Product Change Notification / SYST-05XJMF681

ERRATA - PIC18(L)F26/45/46K40 Family Silicon Errata and Data Sheet Clarification

PIC18(L)F26/45/46K40 Family Silicon Errata and Data Sheet Clarification

Figure 1. 28-pin SPDIP, SSOP, SOIC

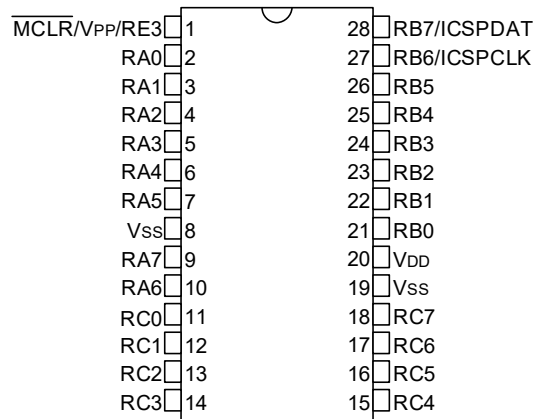
The correct marking for pin 26 on the 28-pin SPDIP/SSOP/SOIC package is **RB5**.

Figure 3. 40-pin PDIP

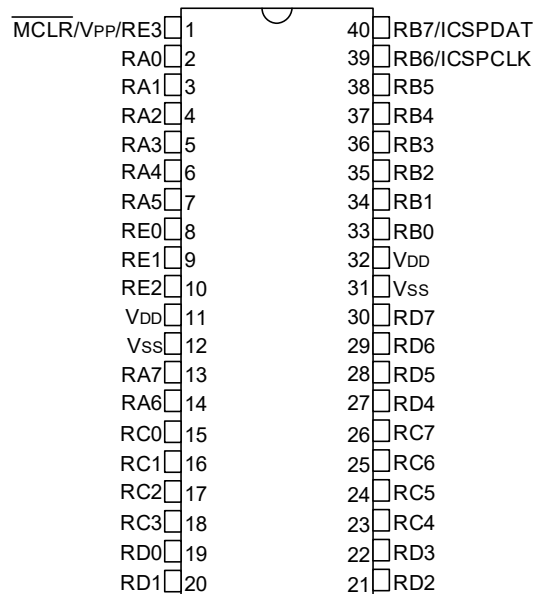
The correct marking for pin 38 on the 40-pin SPDIP package is **RB5**.

Figure 38-10: ADC Conversion Timing (ADC Clock F_{OSC} -Based)

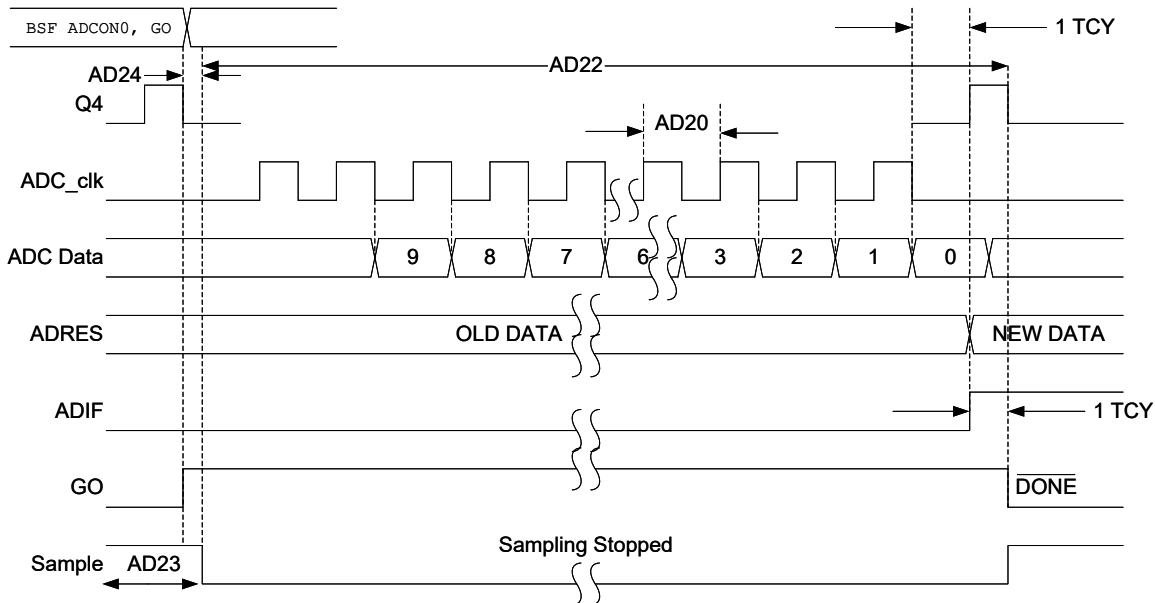
Refer to the images below for corrections of Figure 38-10 and Figure 38-11. Previously, the parameter numbers were incorrect.
